HYDROLOGY

VICTORY LOVE FELLOWSHIP CHURCH

SITE PLAN / DRAINAGE PLAN 1" = 50'-0"

REVISED DEC. 2, 1985
Revised May 7, 1987
Revised August 31, 1987

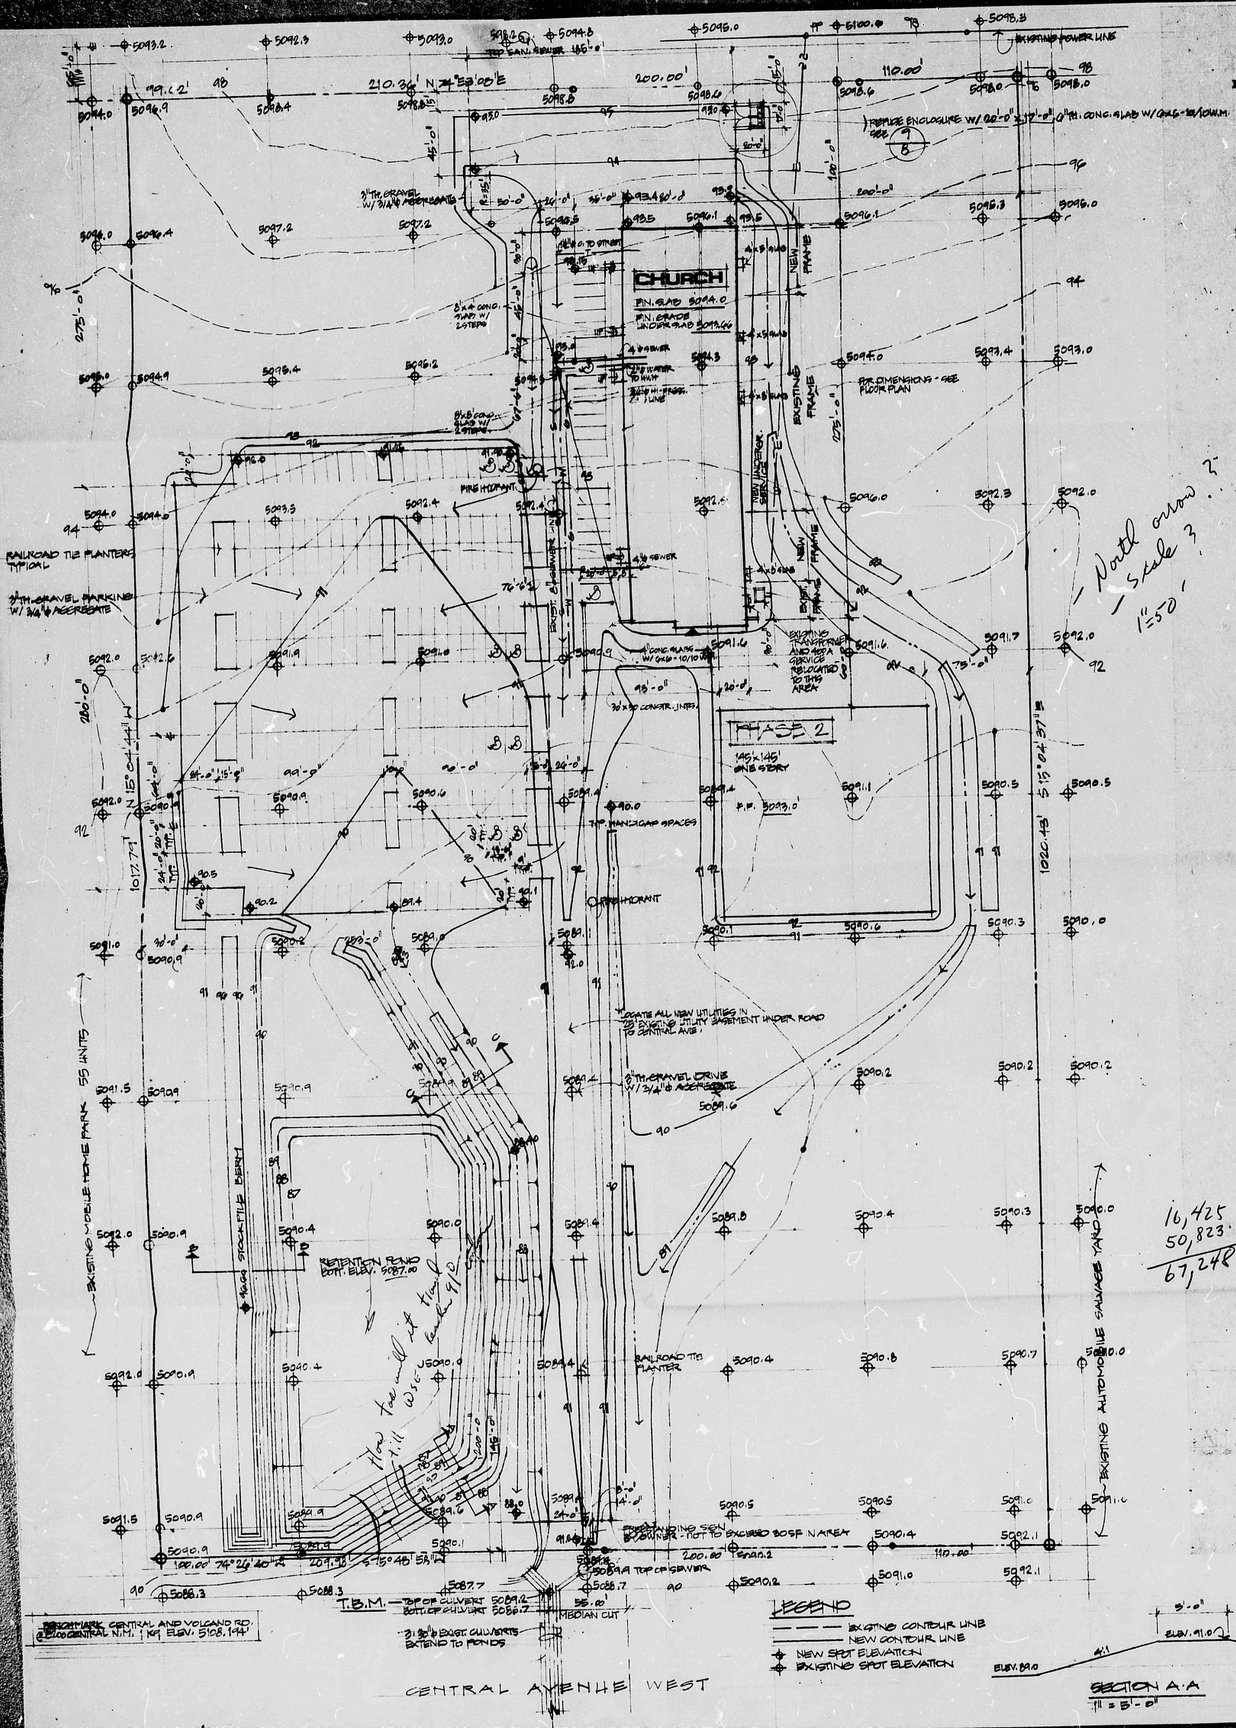
50,823
- 40,186
10,637
NO

16,425 NO!
50,823
67,248 CF

F. Total Retention Volume
27060 + 4950 + 25870 = ~~57880~~ cf
67,248 98,068 CF
